Rural and Renewable Energy Agency (RREA)

# Small hydropower plant Kaiha 2, Liberia

## Review of Hydrology & Hydraulic Works

### FINAL REPORT

Figure 4 Freeboard design: concrete dam and embankment dam cross sections.

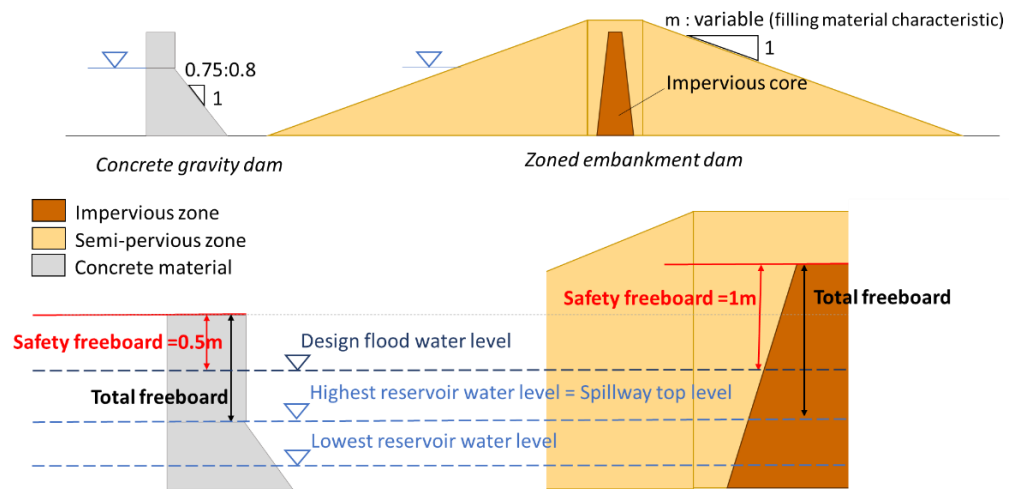
Design considerations for same operating water level related to dam's type are shown on Figure 4.

For a zoned embankment dam, the required freeboard provides the setting top level for the impervious core. Concrete dam freeboard value is lower because of its submersion ability which gives a stability margin against unexpected floods. Applying such standards to Kaihi 2 project leads to the reference levels on Figure 5.

Figure 5 Freeboard design : levels and freeboard applied to Kaihi 2 project (not to scale)

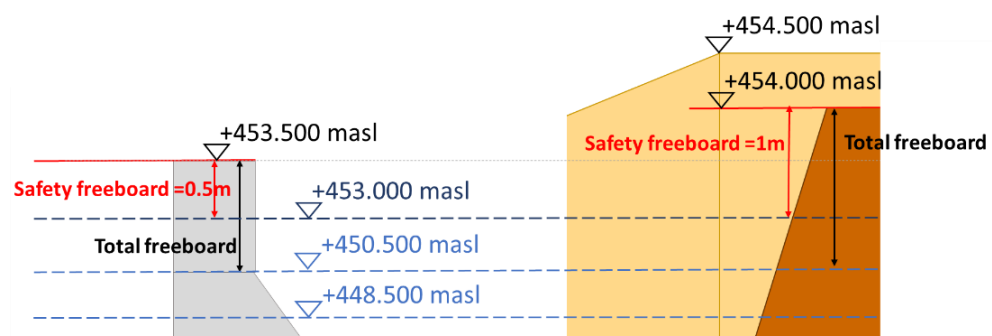
The impervious core top level designed by MTC is in accordance with Swiss standards: freeboard of 1 m above design flood water level.

The length of the overflow concrete dam section is  $L=150\text{m}$  and must be revised considering flood routing, flow contraction, adequate weir profile and so forth. Flood routing should be carried out once reservoir storage curves are available.
